ADDENDUM NUMBER 2

Bid 26-24

Bartlett Street Area Reconstruction

Issued February 2, 2024

SHEET: C-406A

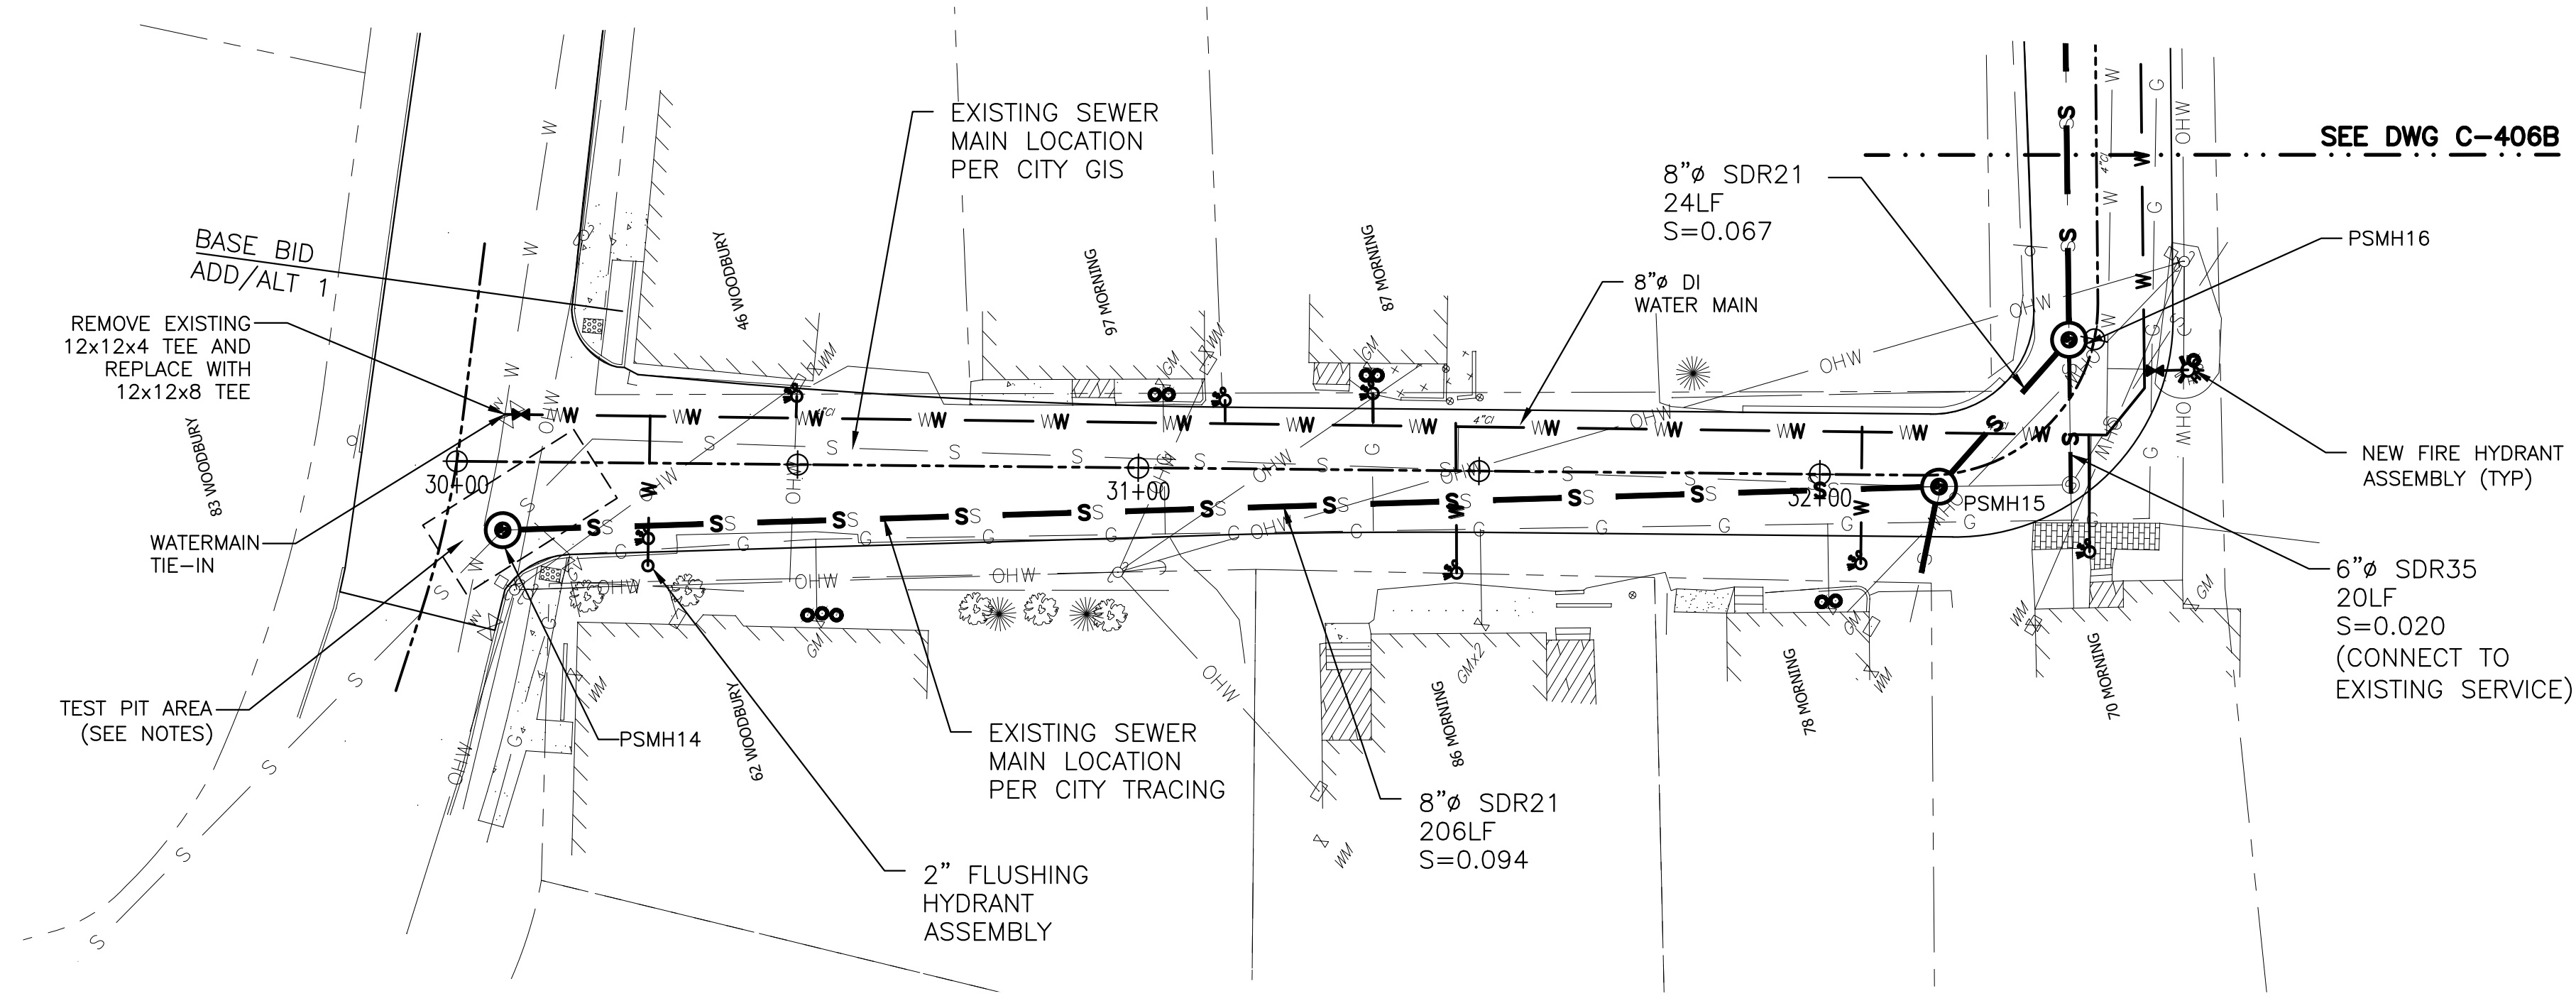
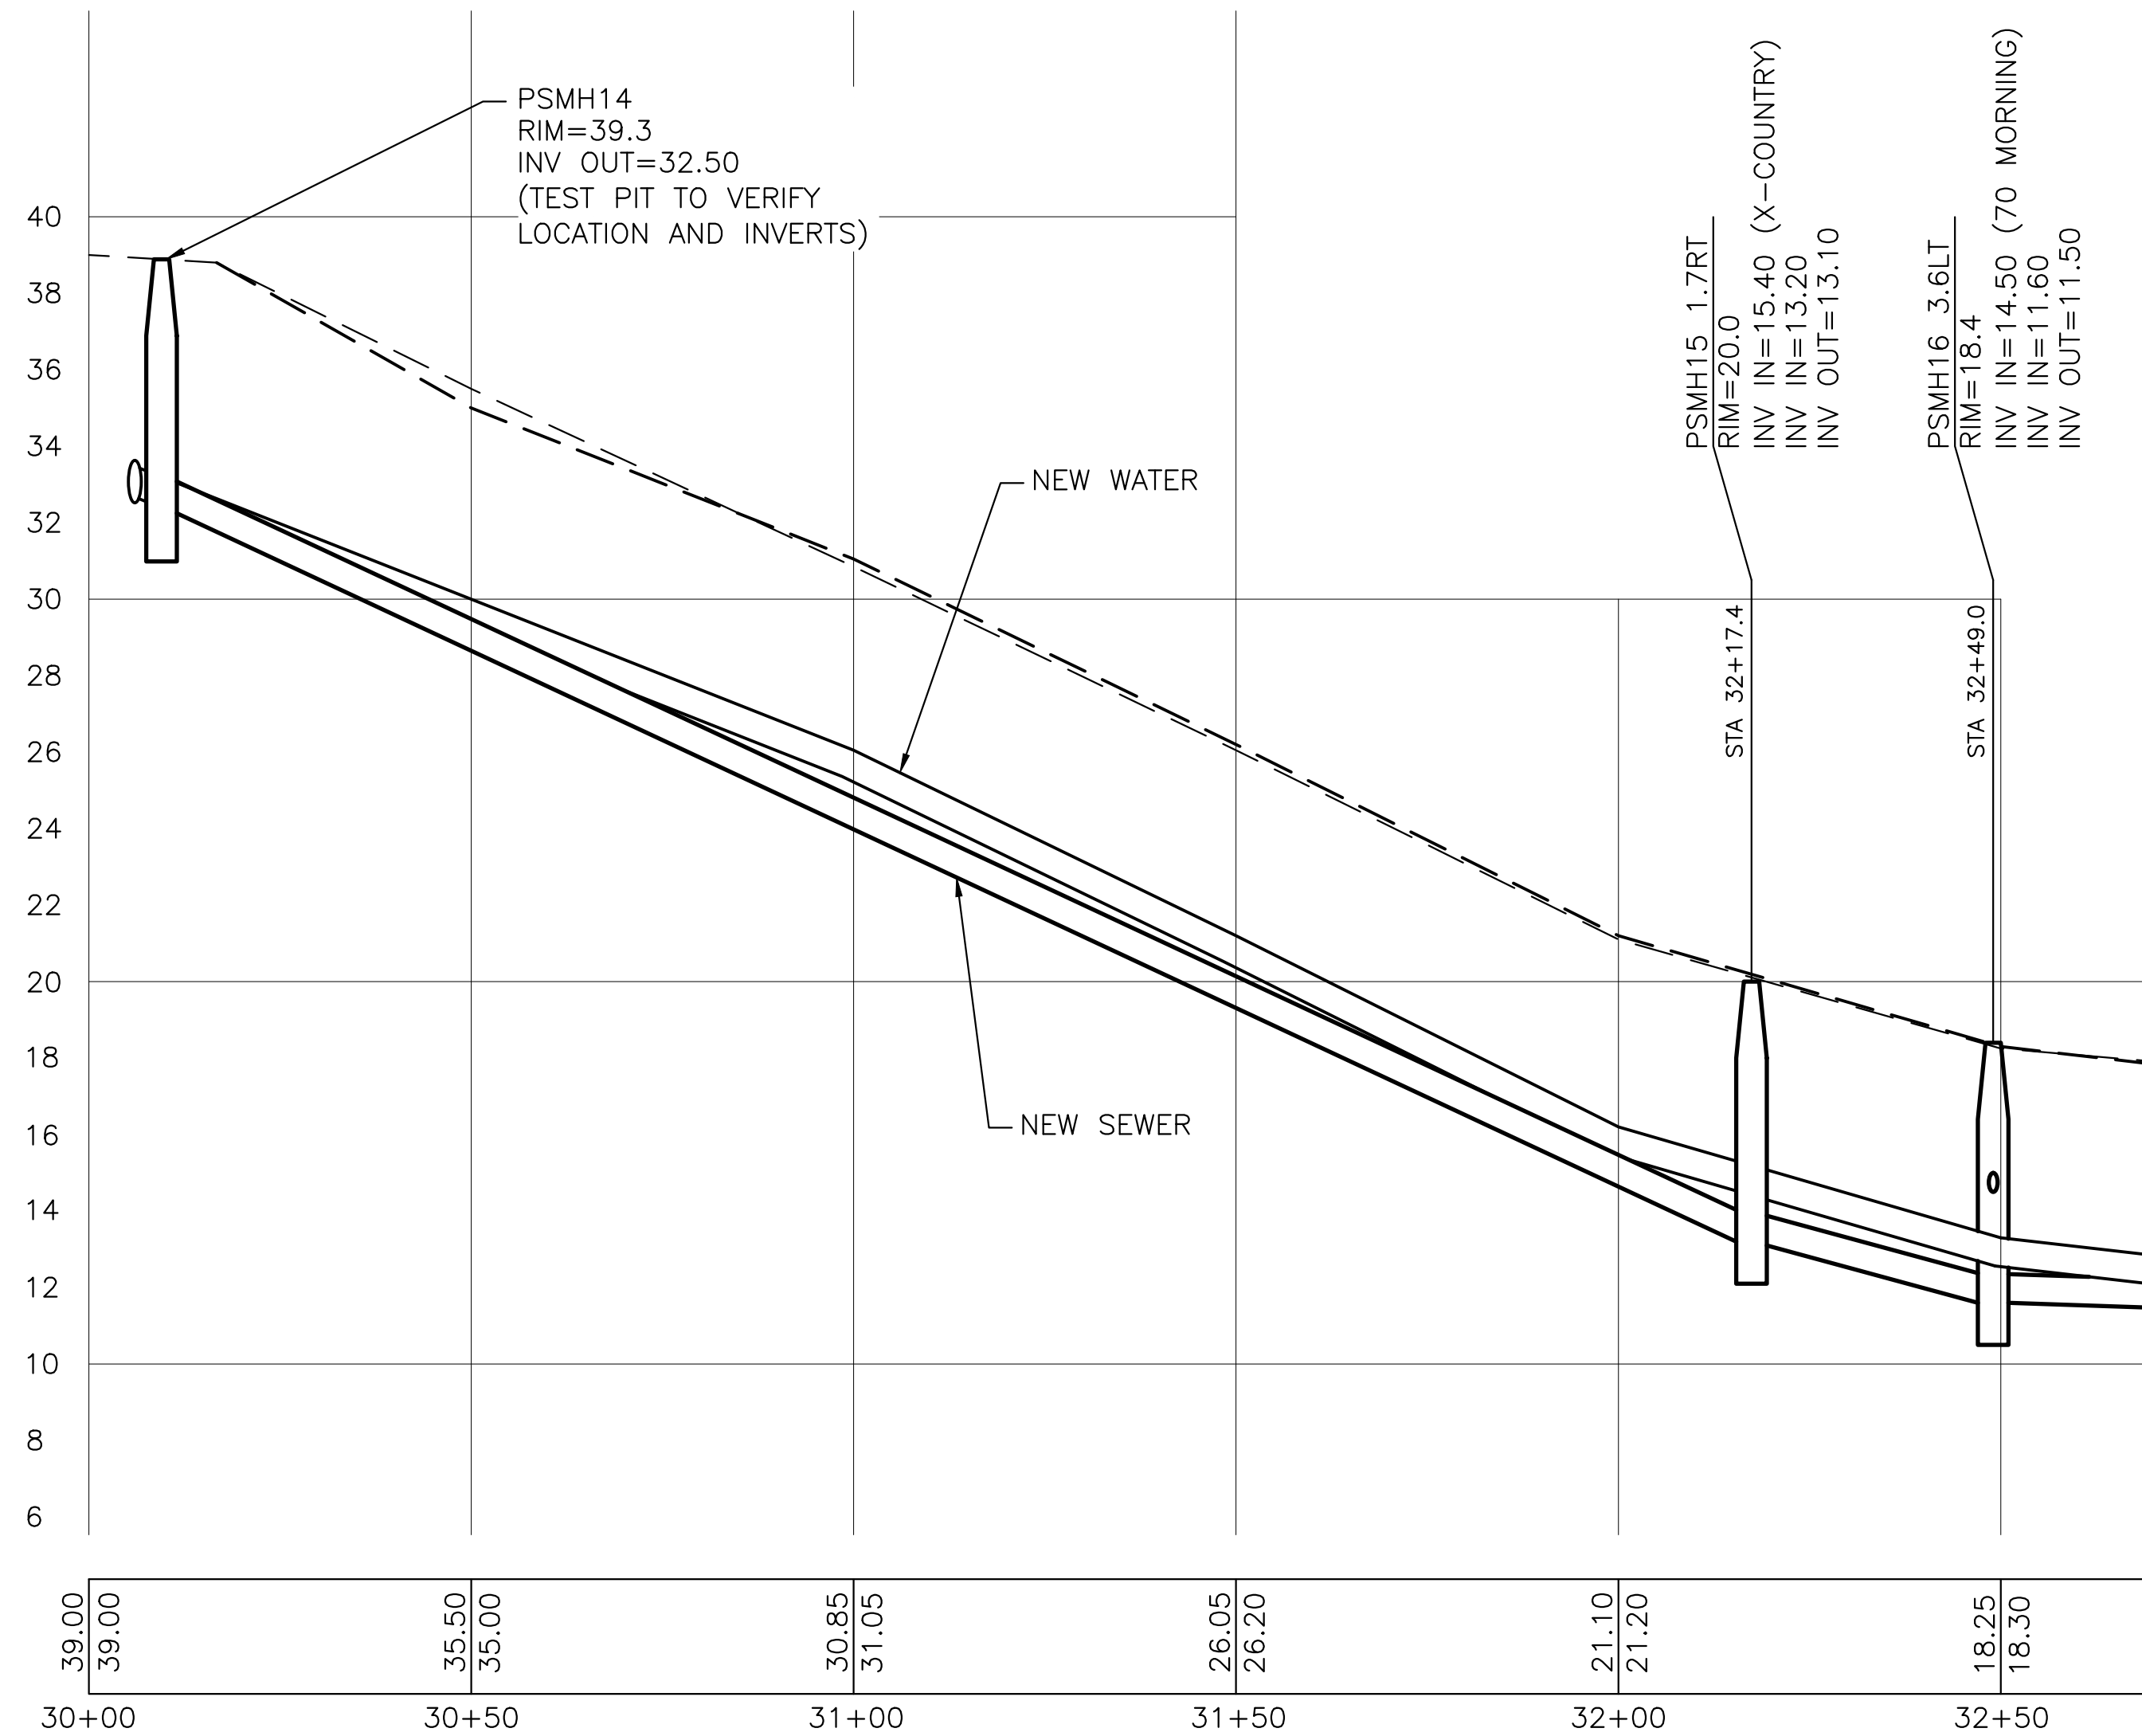
- C-406A – Per NHDES request, added note specifying that information obtained from the test pit location at Woodbury & Morning must be provided to the Engineer. And if any design changes are required based on the information, the design is required to be re-submitted to NHDES for approval prior to constructing.

2. CONTRACTOR SHALL TEST PIT AREA AT WOODBURY & MORNING INTERSECTION TO VERIFY LOCATION WHERE EXISTING SEWER MAIN MAKES TURN DOWN MORNING STREET. THIS IS THE PROPOSED FINAL LOCATION FOR NEW SMH. CONTRACTOR SHALL WORK WITH CITY DPW TO VERIFY OPTIMAL LOCATION FOR SMH PRIOR TO ORDERING STRUCTURE.

5. CONTRACTOR SHALL NOTIFY ENGINEER OF FINAL PSMH14 LOCATION AND INVERT INFORMATION. ENGINEER MAY NEED TO REVISE THE DESIGN TO ACCOMMODATE THE PLACEMENT OF PSMH14 AND SUBMIT TO NHDES FOR APPROVAL.

UTILITY TRENCH
SCALE: N.T.S

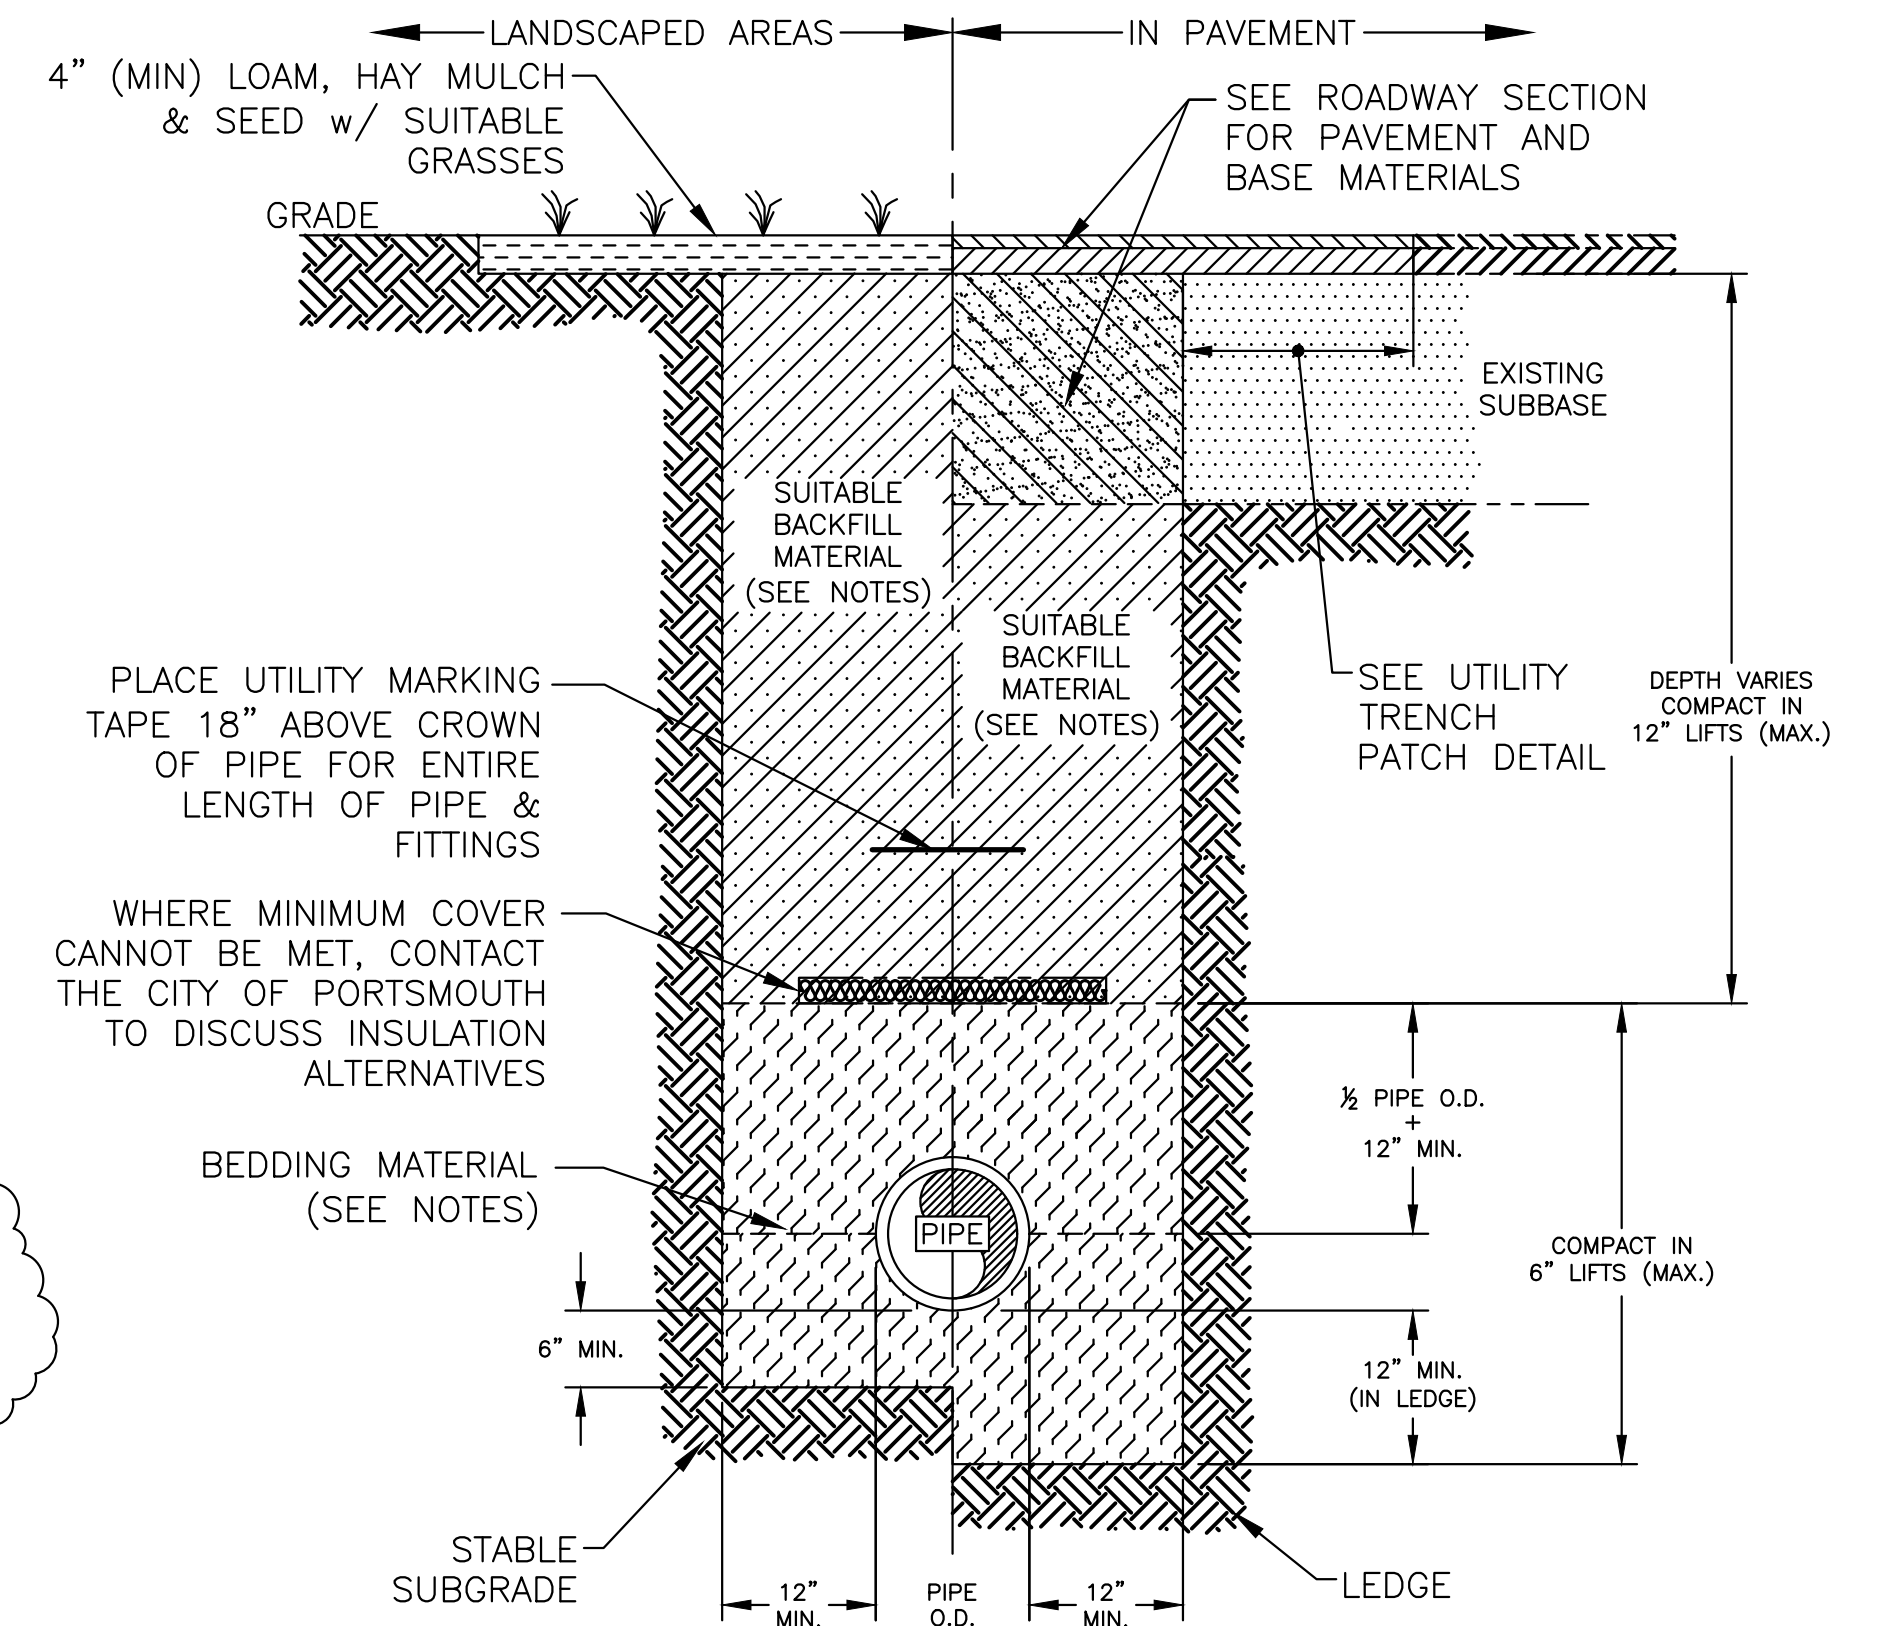
- C-401 to C-406B – Notes were added to each sheet regarding requirements for any non-gasketed pipe connections (i.e. FERNCO).
- C-604 – Utility Trench Detail – Per NHDES request, a note was added to clarify the location of rigid foam above the utility and the minimum width of foam when depth requirements are not met.

- 2" RIGID FOAM INSULATION SHALL BE PLACED ON TOP OF BEDDING MATERIAL. BEDDING MATERIAL SHALL BE MADE SMOOTH TO ALLOW FOAM BOARD TO SIT WITHOUT VOIDS BENEATH. FOAM SHALL BE INSTALLED THE FULL WIDTH OF THE TRENCH, NOT TO EXCEED 4' WIDE.
